NORTHERN STATES POWER COMPANY
414 Nicollet Mall
Minneapolis, MN 55401

OPERATIONAL QUALITY ASSURANCE PLAN

REVISION 18

| | <u>Page</u> |
|--|-------------|
| 2 Appendix D - Revision 18 Change Summary | 78 |

Figure 1
Quality Assurance Responsibilities

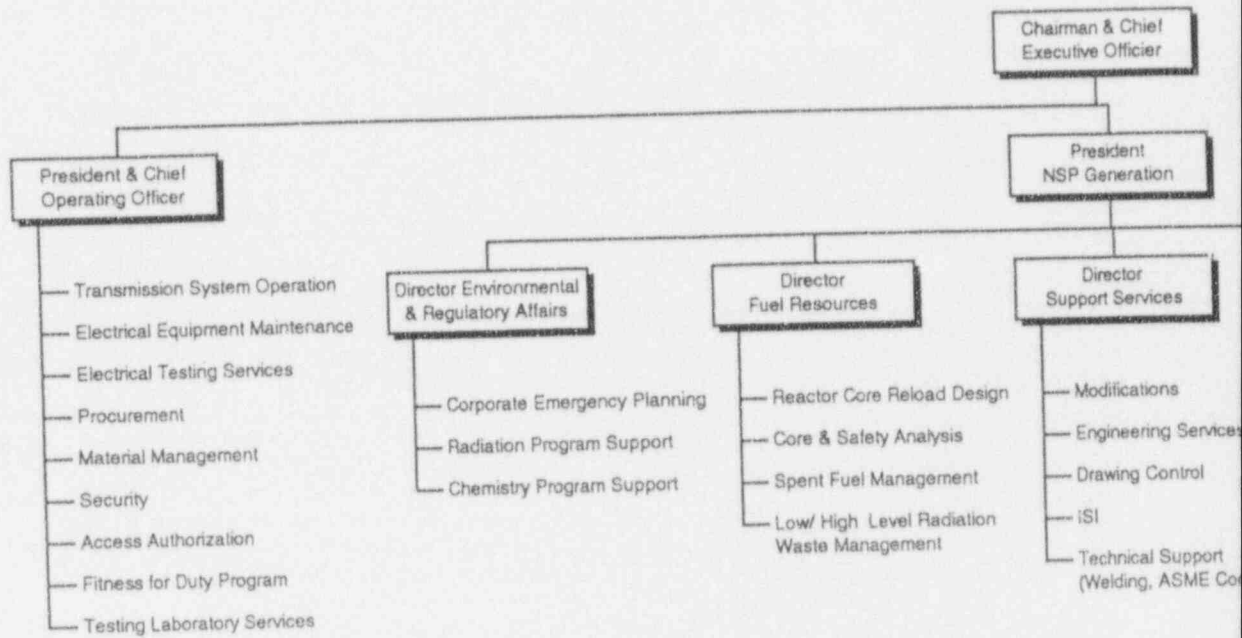
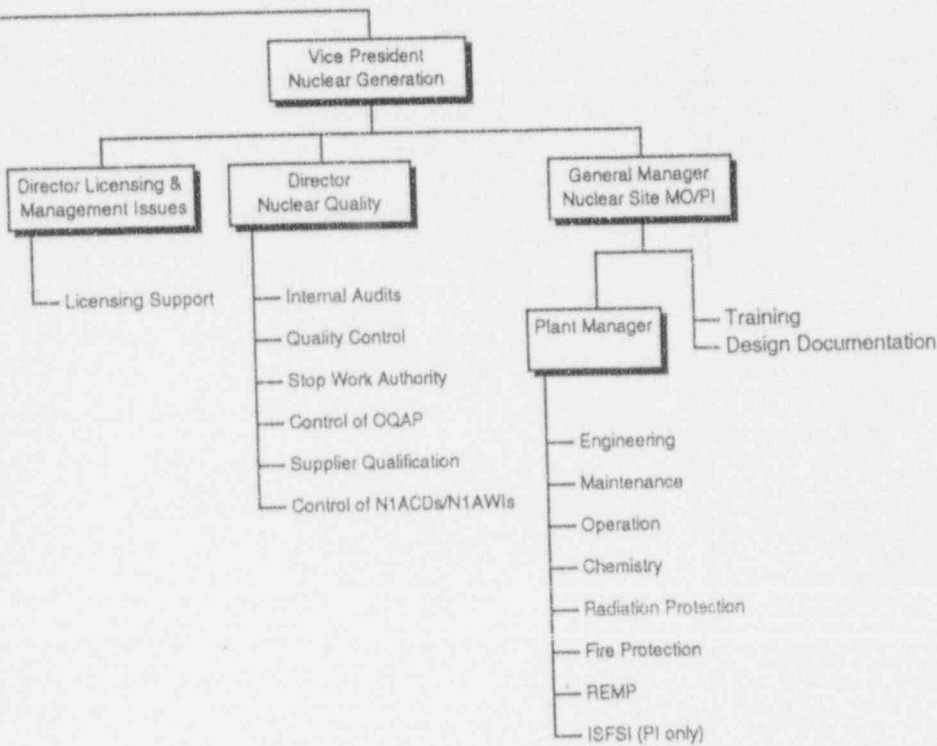
| <u>Change Number</u> | <u>Page(s)</u> | <u>Reason/ Basis</u> |
|----------------------|-----------------------------------|---|
| 7 | 7, 8 (Figure 1) | <p>R: Simplified description of NSP organization with QA responsibilities by limiting portrayal of organization to key management positions and including only brief descriptions of functional areas of responsibility instead of detail listing of responsibilities and tasks.</p> <p>B: Reduction in commitment per 50.54(a)(3) submitted with OQAP revision 18.</p> |
| 9 | 7, 8 (Figure 1) | <p>R: The following title change occurred since the last OQAP revision, but is not obvious because of the revision to old sections 3.2 and 3.3: Manager Fuel Resources is now the Director Fuel Resources.</p> <p>B: This is a title change only. It does not reduce previous commitments.</p> |

| Change Number | Page(s) | Reason/ Basis |
|------------------|-----------------|--|
| 10 | 7, 8 (Figure 1) | <p>R: The following responsibility changes occurred since the last OQAP revision, but are not obvious because of the revisions to old sections 3.2 and 3.3: (1) The responsibility for the modification of nuclear facilities has been reassigned from the Vice President Nuclear Generation to the Director Support Services; (2) the responsibility for material control has been reassigned from the General Manager Nuclear Site to the President and COO; (3) the responsibility for site quality assurance and quality control has been reassigned from the General Manager Nuclear Site to the Director Nuclear Quality; (4) the responsibility for site security has been reassigned from the General Manager Nuclear Site to the President and COO; and (5) the responsibility for the REMP program has been reassigned from the Manager Nuclear Radiological Services to the Plant Manager.</p> <p>B: These are responsibility assignment changes only. They do not reduce previous commitments.</p> |
| 11 | 7, 8 (Figure 1) | <p>R: The following reporting changes due to reorganization have occurred since the last OQAP revision, but are not obvious because of changes to old sections 3.2 and 3.3: (1) the position of Director Environmental & Regulatory Affairs now reports to the President NSP Generation; and (2) the position of Manager Nuclear Radiological Services now reports to the Director Environmental & Regulatory Affairs.</p> <p>B: This change is based on the corporate reorganization. It does not reduce previous commitments.</p> |
